**JOPPATOWNE HIGH SCHOOL  
LIMITED RENOVATION  
JOPPATOWNE, MARYLAND**

**ADDENDUM NO. 5**

**May 18, 2020**

AD-5 SK-2 PART E3.03

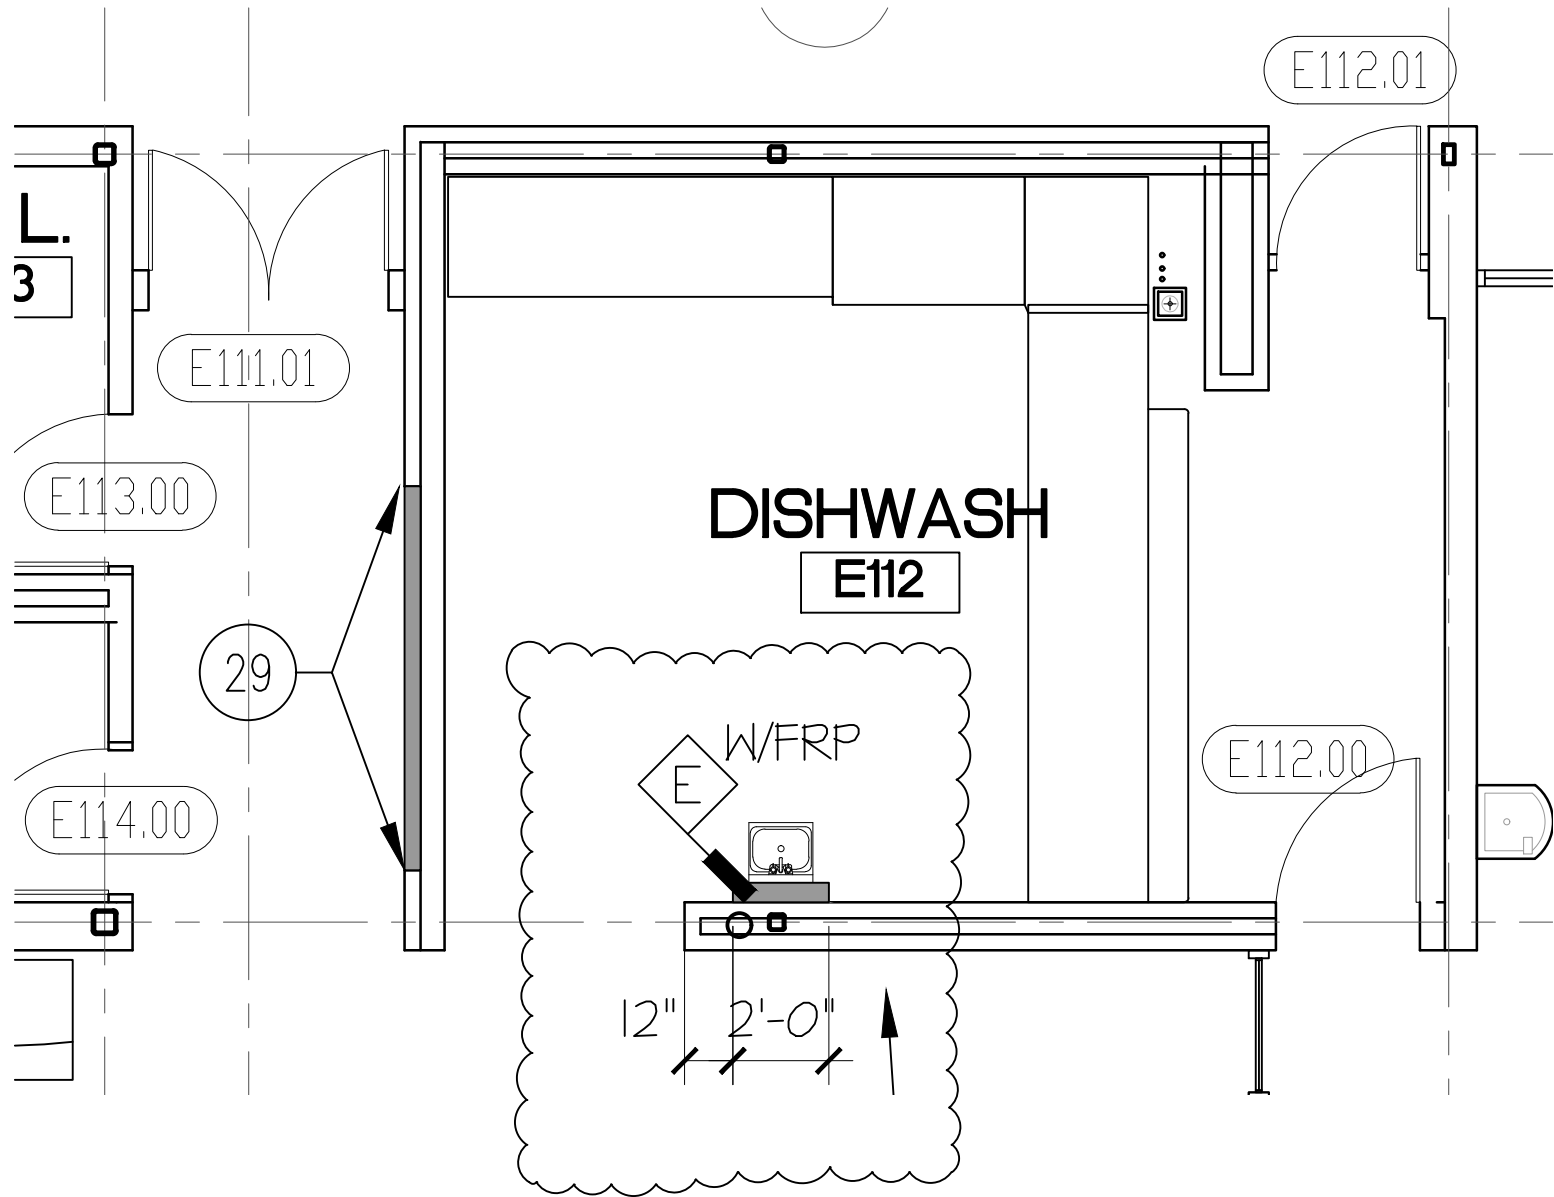
- A5.13 DRAWING A-2.3: Corridor C101: Change note "4" to Note "1". New ceiling grid and tile in the Corridor.  
Toilet Rooms E128 and E129 to be indicated with Note 5. See attached Sketch AD-5 SK-1 for ceiling grid layout.

AD-5 SK-2 – Part E3.03 Toilet Room Lighting Plan

**AD-5 SK-3 PART A-1.5**

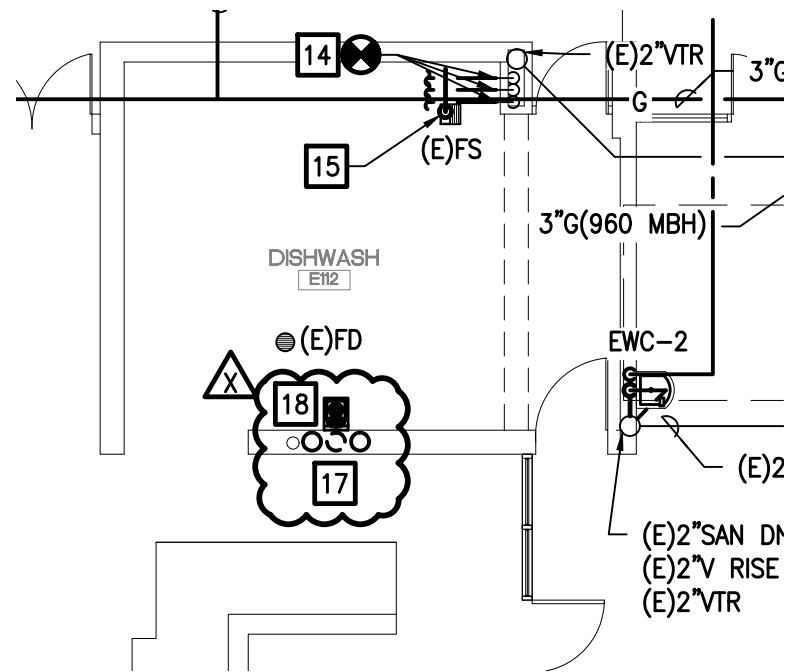
- A5.15 DRAWINGS A-6.8, P2.05, P2.09: Health Department review of the project requires a hand-wash sink to be installed in Dishwashing E112. See attached part plans AD-5 SK-3, and AD-SK-4 for location and information for added handwash sink.

AD-5 SK-3 – Part A-1.5 Dishwashing E112 – added handwash sink.

AD-5 SK-4 PART P2.05 P2.09

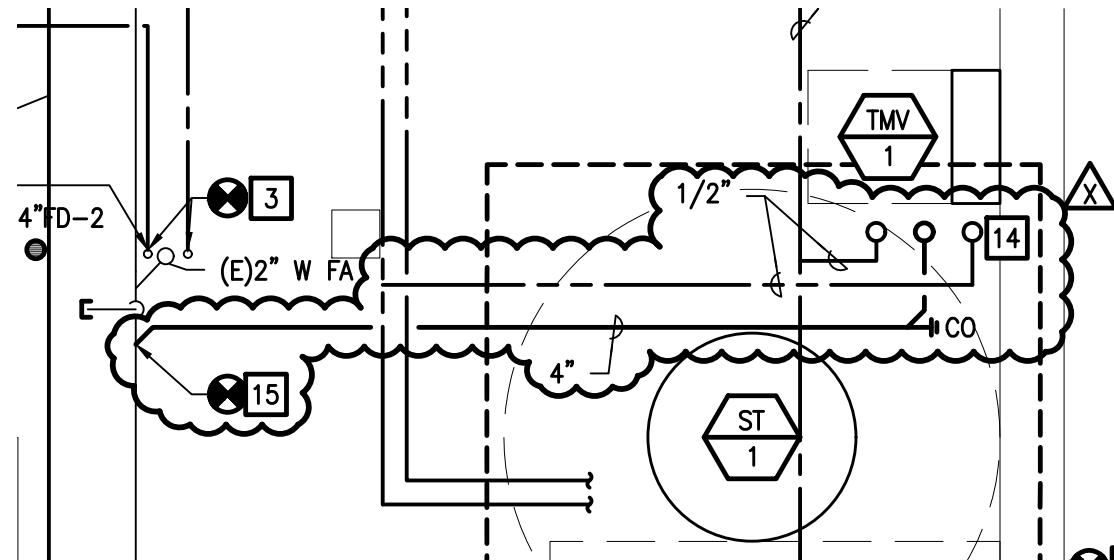
AD-5 SK-4 – Part P2.05 and P2.09 – plumbing for added handwash sink.

AD-5 SK-6 PART M0.21

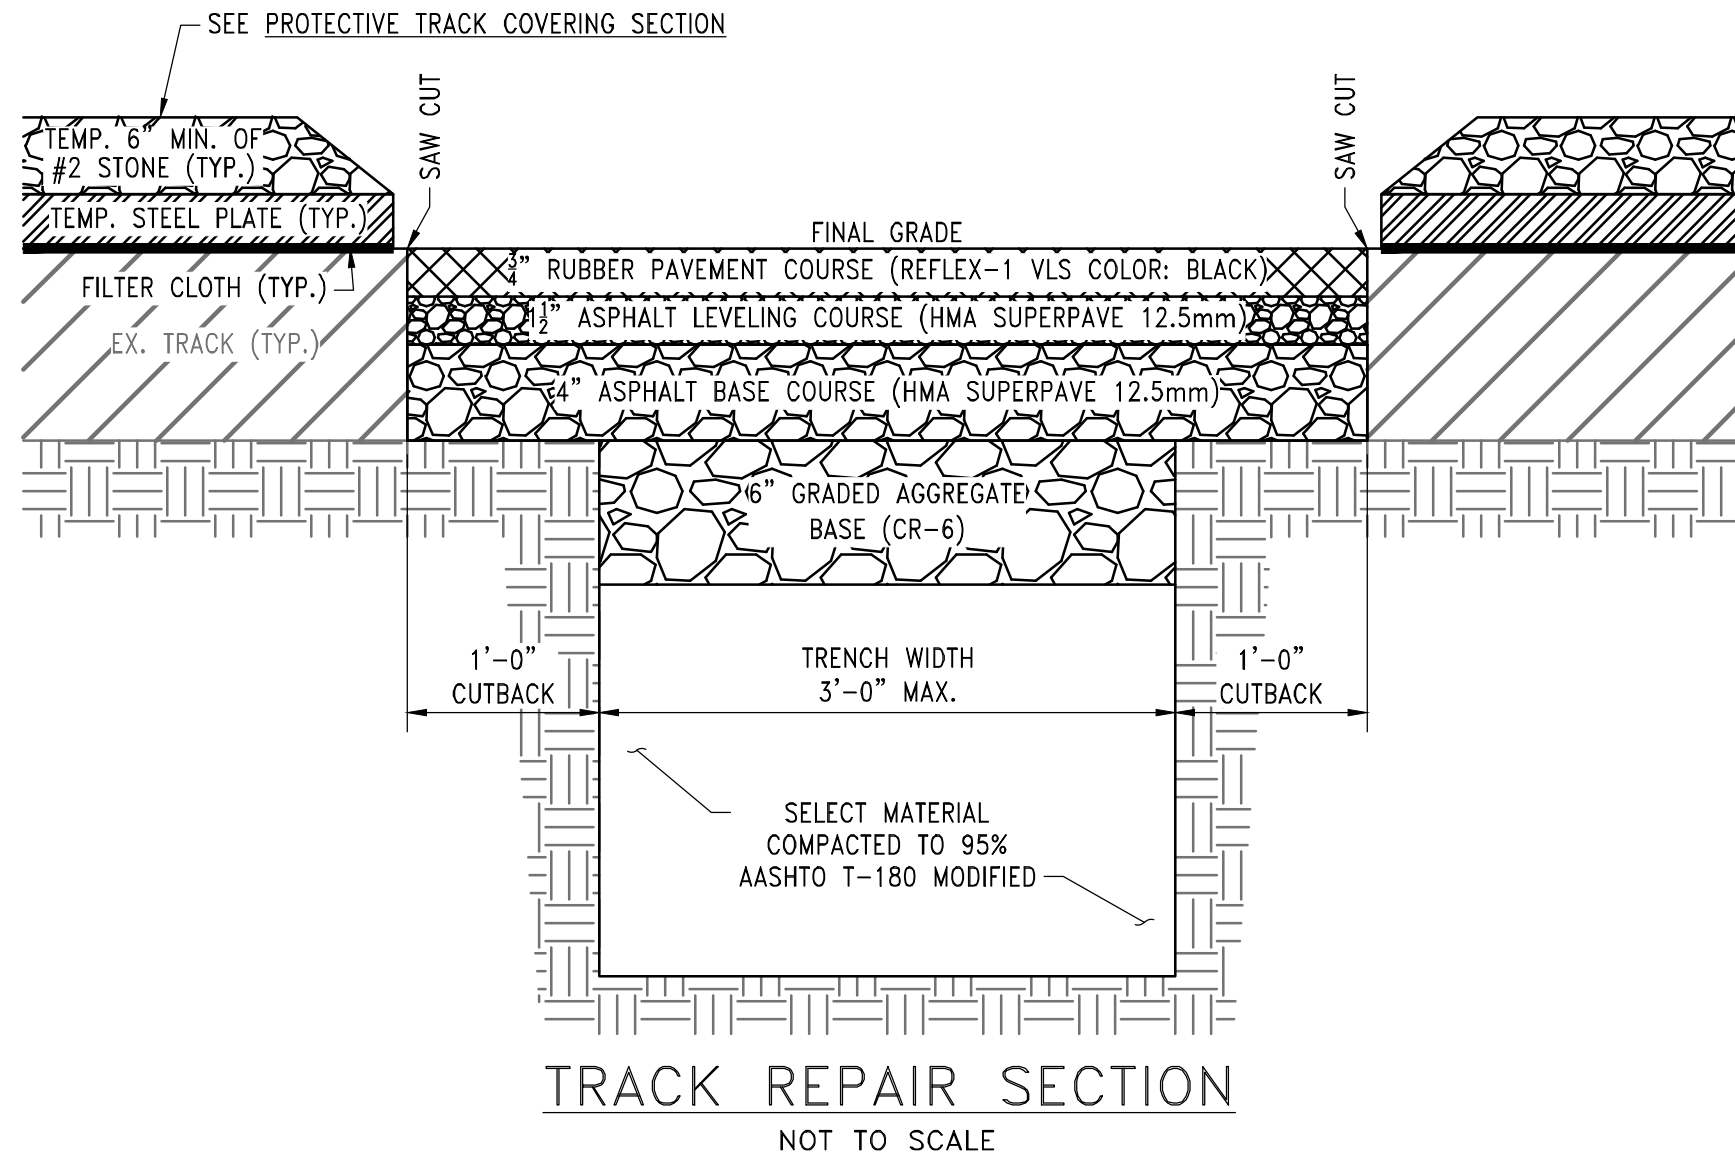
AD-5 SK-6 – PART M0.21: Air Cooled Chiller schedule has been revised. Total tonnage of chiller has been increased to meet the total connected load of chilled water system.

# AD-5 SK-7 PART M0.22

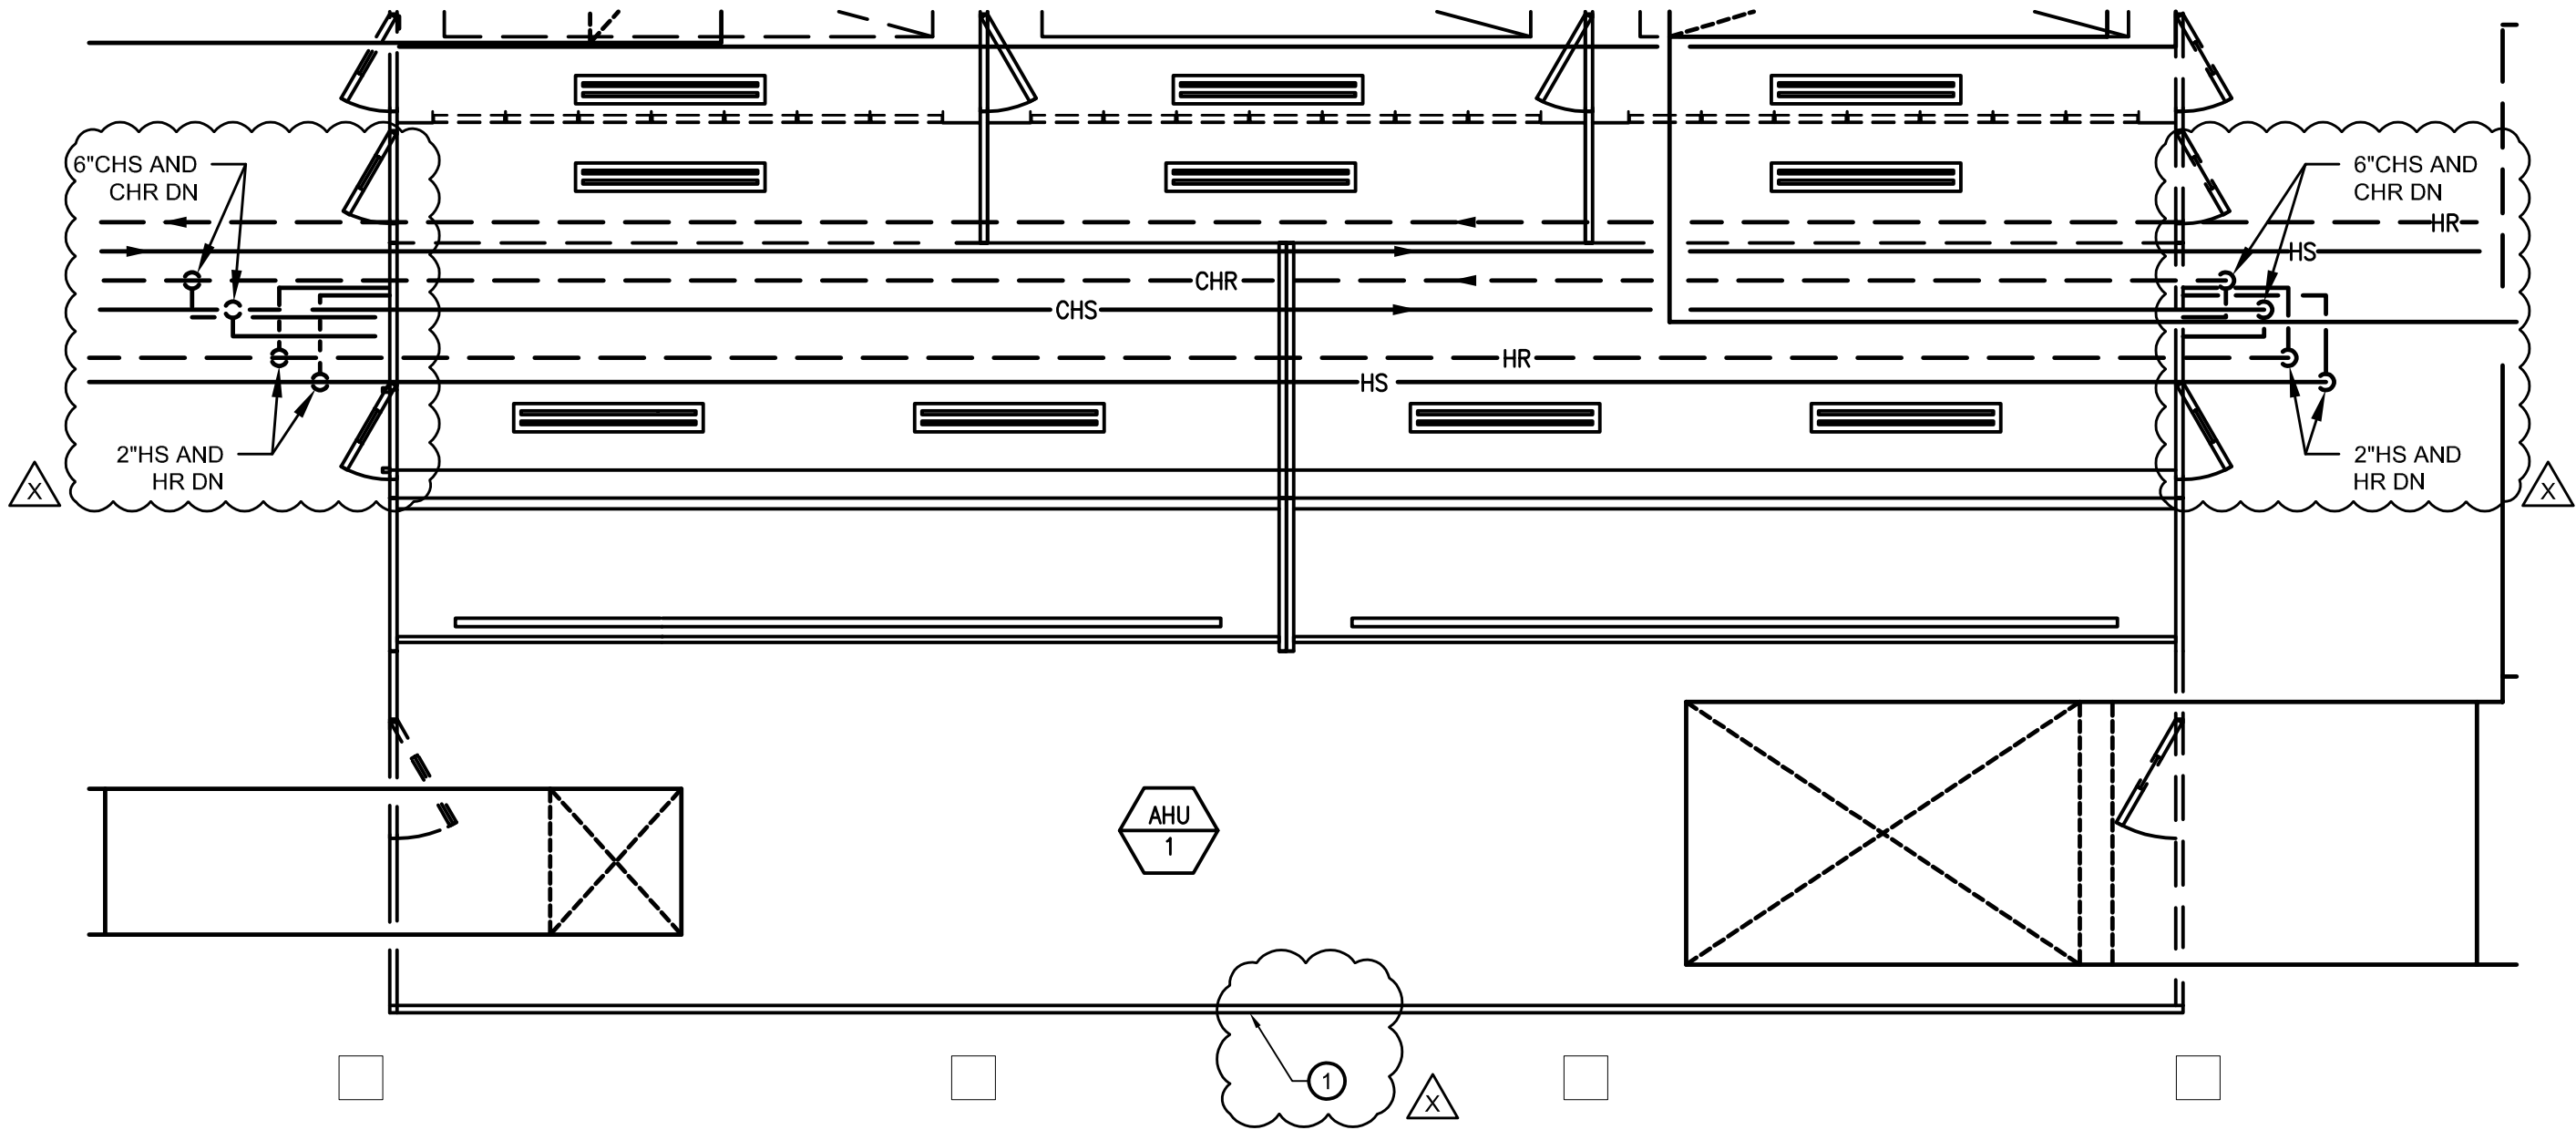
AD-5 SK-7 – PART M0.22:

A. Dedicated Outside Air System “DOAS-1” schedule has been revised to include information regarding the Energy Recovery Wheel and Exhaust Fan.

B. Pump schedule has been revised. Pump capacities has been revised to meet the total connected demands in both the heating water and chilled water systems.

C. Energy Recovery Wheel specification included for pricing of any Energy Recovery Wheels in project.
